# Access Compliance Report

## Public Rights-of-Way

### (Curb Ramps)

Intersection ID: 10021	Main Street: S_I-85_RA	Cross Street: TUCKASEEGEE_RD	Location: E
ADA ID: 3D805F8DBD2C	Ramp Type: Perp	Initial Pass/Fail: Fail	Overall Compliance: No
Severity Score: 22.5			
Codes/Mitigation Info/Possible Solution		Field Measurements/Component Compliance

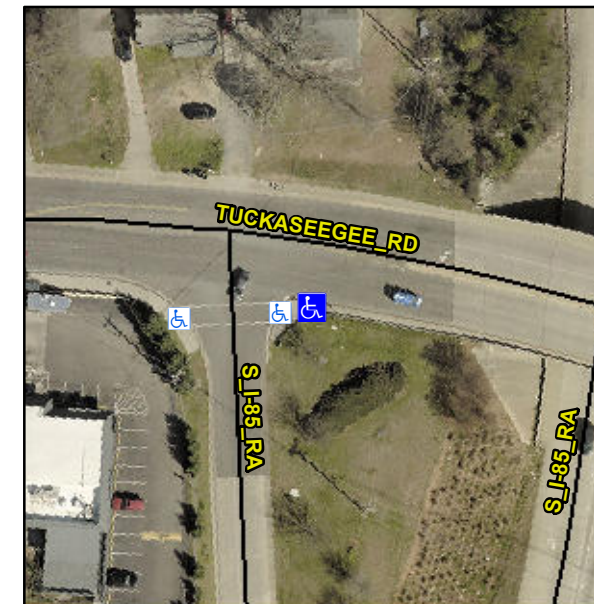
**Not Found, R304.5.1, R304.2.2, R304.5.3**

Compliance	Description	Data	Compliance	Description	Data
N/A	Ramp Length (in)	55.0	No	Ramp Slope (%)	11.1
No	Ramp Width (in)	39.0	No	Ramp XSlope (%)	2.7
N/A	Flare Type LT	N/A	N/A	Flare Type RT	N/A
N/A	Flare Slope LT (%)	N/A	N/A	Flare Slope RT (%)	N/A
N/A	Flare Traversable LT?	N/A	N/A	Flare Traversable RT?	N/A
N/A	Landing Length (in)	N/A	N/A	DWS Provided?	N/A
N/A	Landing Width (in)	N/A	N/A	DWS Contrast?	N/A
N/A	Landing Slope (%)	N/A	N/A	DWS Length (in)	N/A
N/A	Landing X Slope (%)	N/A	N/A	DWS Full Width?	N/A
N/A	Landing Curb? (Y/N)	N/A	N/A	DWS Offset (in)	N/A
N/A	Shared Landing?	N/A			
N/A	Gutter Ponding?	N/A	N/A	Gutter Slope (%)	N/A
N/A	Gutter Lip Ht (in)	N/A	N/A	Gutter X Slope (%)	N/A
N/A	Painted X Walk1?	No	N/A	Painted X Walk2?	N/A
	X Walk 1 Direction	To N		X Walk 2 Direction	N/A
N/A	X Walk 1 Width (in)	N/A	N/A	X Walk 2 Width (in)	N/A
	X Walk 1 Slope (%)	0.7		X Walk 2 Slope (%)	N/A
	X Walk 1 X Slope (%)	2.2		X Walk 2 X Slope (%)	N/A

**Remove & Replace Entire Ramp.**
